Serial No.: 09/904,676
Amendment Dated: September 29, 2003
Reply to Office Action of April 28, 2003

AMENDMENTS TO THE DRAWINGS:

FIG. 1

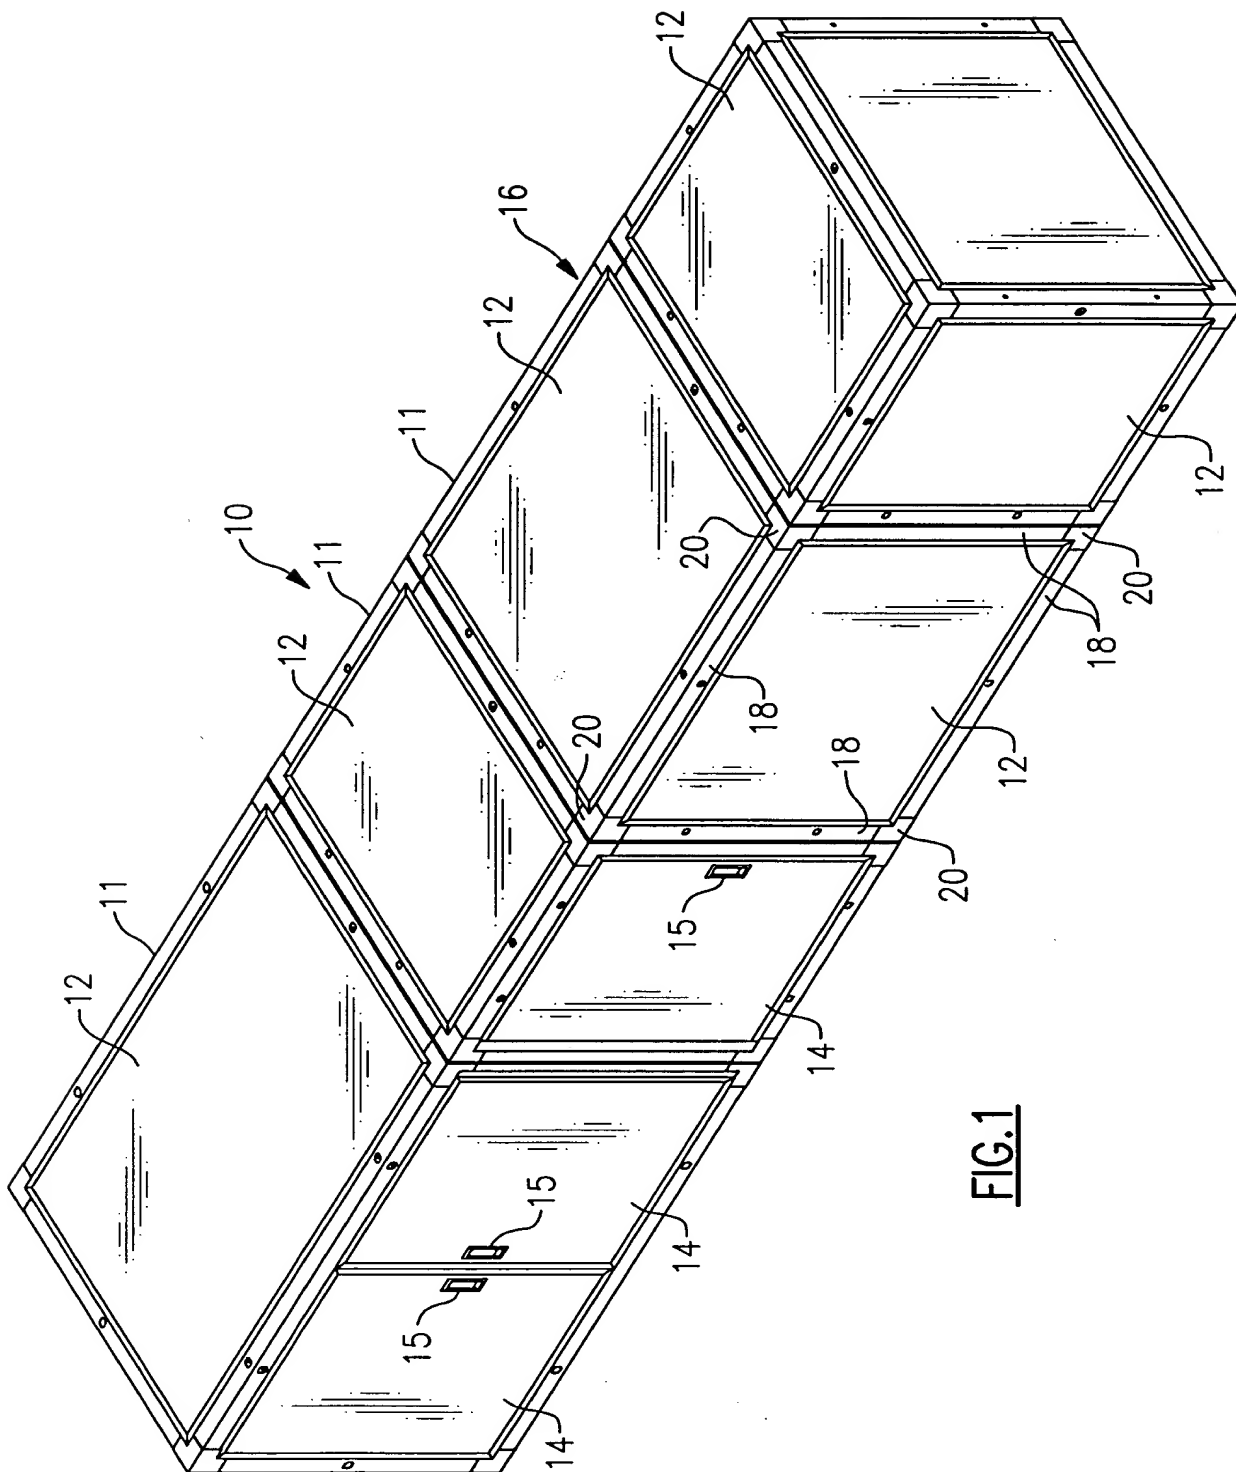
The proposed drawings corrections have been approved. However, the drawings are objected to because of numeral 16 not including an arrowhead. Further, the addition of numerals 11 have been added to accommodate an amendment to the specification. These changes have been incorporated into formal drawings being submitted herewith.
